Consultant Wahib Medanat Consultant Engineers Rep No. QC-12 06

Site Name Al Khansa'a Basic Mixed - Balga **Date** 14 / 09 / 2021

Descr	iption	of	Non-	
Co	nform	an	ce

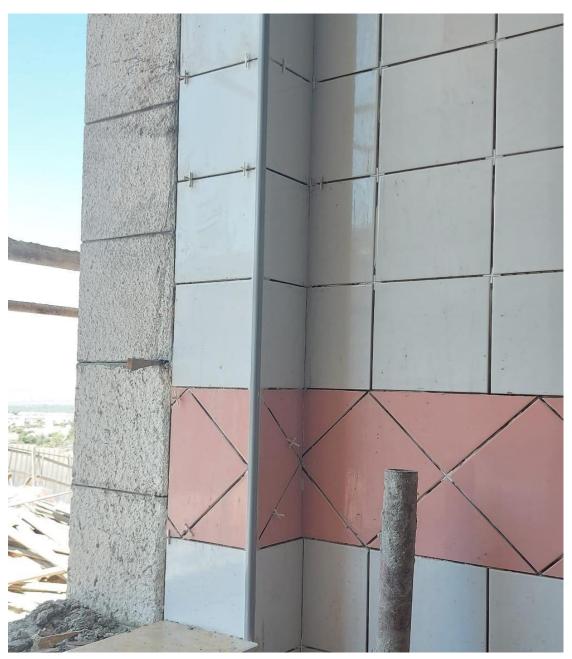
- 1. Window sill bottom edge is toothed and not straight.
- 2. No beads installed at corner for tiling work, no. of electrical outlets is not located right.
- 3. The level of window sill is not at design level to avoid conflict its design level precisely and without created groove at its bottom.
- 4. The sheet waterproofing for septic tank and water tank are exposed for long time.

- 1. To be replaced.
- 2. Plastic beads should be installed at external corners. Outlets to be re-located.
- 3. The sill should be at its with furniture and corridor cabinets. A groove should be created below.
- 4. Cartonal should be fixed to protect the sheets and backfilling should be executed.

The contractor responsed and rectified 1,3,4. 2 still not rectified.
